Access Compliance Report

Public Rights-of-Way

Intersection ID: 11306	Main Street: W_9TH_ST	Cross Street: N_SMITH_ST	Location:	N
ADA ID: 86D20985E8D2	Ramp Type: PerpDiag	Initial Pass/Fail: Fail	Overall Compliance: No	Severity Score: 8.75
Codes/Mitigation Info/Possible Solution		Field Measurements/Component Compliance

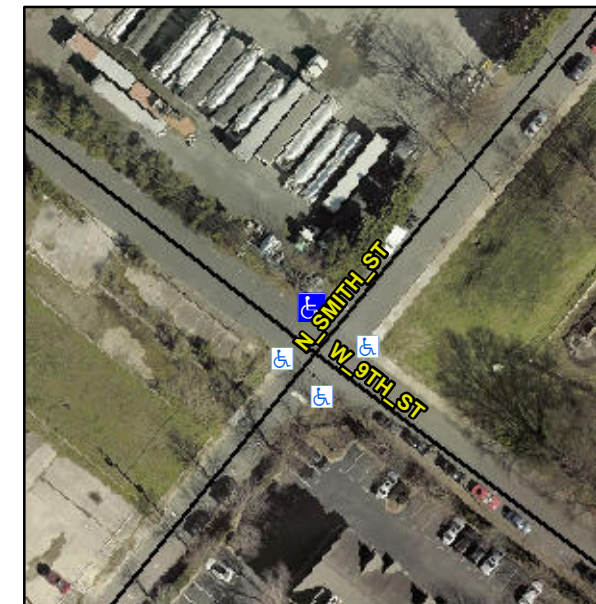
Not Found, R304.5.1

Compliance	Description	Data	Compliance	Description	Data
N/A	Ramp Length (in)	49.0	Yes	Ramp Slope (%)	5.4
No	Ramp Width (in)	40.0	Yes	Ramp XSlope (%)	1.5
N/A	Flare Type LT	N/A	N/A	Flare Type RT	N/A
N/A	Flare Slope LT (%)	N/A	N/A	Flare Slope RT (%)	N/A
N/A	Flare Traversable LT?	N/A	N/A	Flare Traversable RT?	N/A
N/A	Landing Length (in)	N/A	N/A	DWS Provided?	N/A
N/A	Landing Width (in)	N/A	N/A	DWS Contrast?	N/A
N/A	Landing Slope (%)	N/A	N/A	DWS Length (in)	N/A
N/A	Landing X Slope (%)	N/A	N/A	DWS Full Width?	N/A
N/A	Landing Curb? (Y/N)	N/A	N/A	DWS Offset (in)	N/A
N/A	Shared Landing?	N/A			
N/A	Gutter Ponding?	Yes	N/A	Gutter Slope (%)	N/A
N/A	Gutter Lip Ht (in)	N/A	N/A	Gutter X Slope (%)	N/A
N/A	Painted X Walk1?	No	N/A	Painted X Walk2?	No
	X Walk 1 Direction	To SW		X Walk 2 Direction	To SE
N/A	X Walk 1 Width (in)	N/A	N/A	X Walk 2 Width (in)	N/A
	X Walk 1 Slope (%)	4.4		X Walk 2 Slope (%)	5.5
	X Walk 1 X Slope (%)	1.0		X Walk 2 X Slope (%)	2.1

Remove & Replace Curb Ramp With Two New Directional Ramps or Equivalent.
